SCHWEIZER SERVICE LETTER

L-161
07 Apr 1997

SUBJECT: NEW IMPROVED CLUTCH SPRING RETAINER

MODELS AFFECTED: 269 Series Helicopters with 269A5590-1 clutch spring assembly installed

Figure L-161-1. New Spring Retainer and Stainless Steel Spring

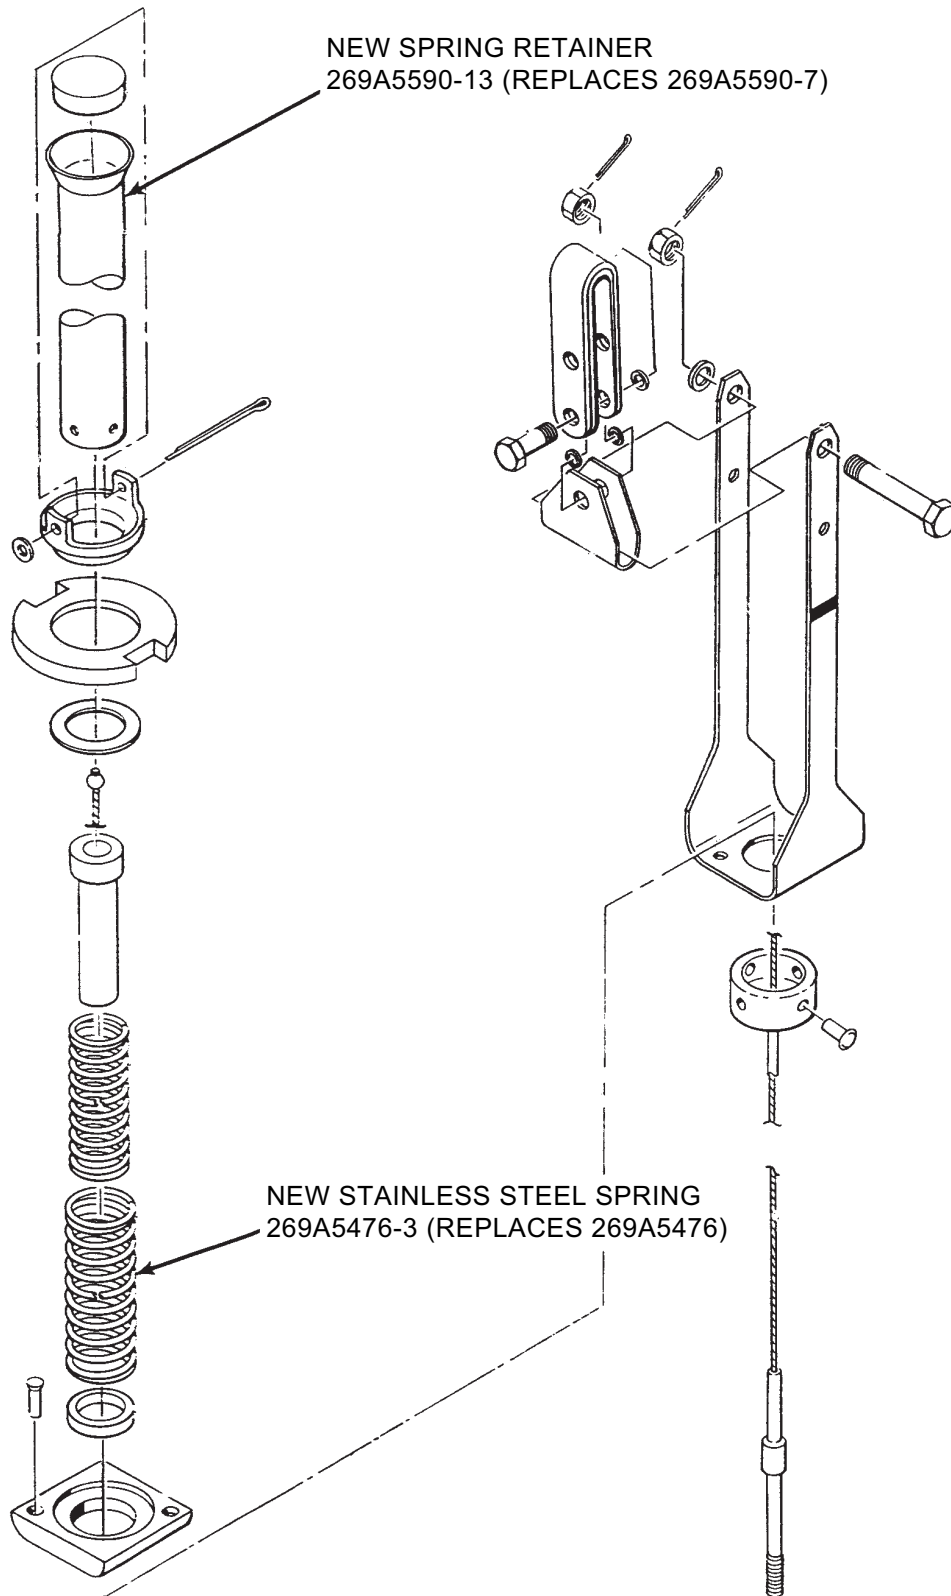
The 269A5590-1 clutch spring assembly has been improved to eliminate the 2695590-101 thermofit tube on the spring retainer. The 269A5590-7 spring retainer has been replaced with a 269A5590-13 spring retainer. The new spring retainer has a permanent titanium oxide coating in place of the 2695590-101 thermofit tube. This new coating provides a superior no-maintenance wear surface; however, the hard coating would have a tendency to wear through the cadmium plating on the 269A5476 spring. It is, therefore, necessary to install a new 269A5476-3 stainless steel spring in conjunction with the new 269A5590-13 retainer (Figure L-161-1, Page 2 of 2).

The 269A5590-101 thermofit tube is no longer available. When your currently installed thermofit tube is worn through, the clutch spring assembly must be upgraded to the new improved configuration by installing the new 269A5590-13 retainer and 269A5476-3 stainless steel spring as a set. These parts must be ordered individually; they are not available as a kit.
